NUMBER: 08-003-21 REV. A

SUBJECT:

Improved Steering Feel

2018 - 2020	(JL)	Jeep Wrangler
2020	(JT)	Jeep Gladiator

Fig. 1

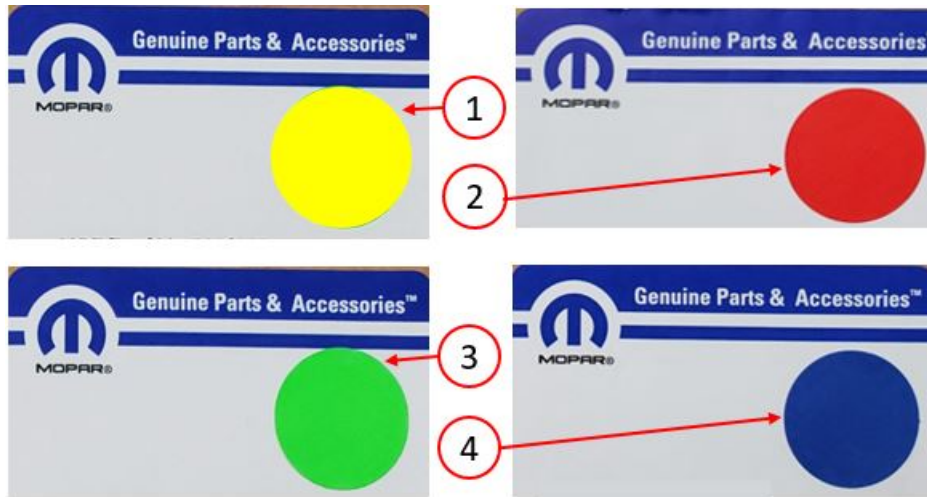
The Steering Gear Parts Label Has A Color Dot On It To Help Confirm The Correct Steering Gear Was Ordered

- 1 - Yellow Dot, 68507576AA (JT Left Hand Drive (LHD))
- 2 - Red Dot, 68507569AA (JL 4 Door LHD, **W/O EXJ 3.0 Diesel**)
- 3 - Green Dot, 68507574AA (JL 4 Door LHD, **With EXJ 3.0 Diesel**)
- 4 - Blue Dot, 68507571AA (JL 2 Door LHD)
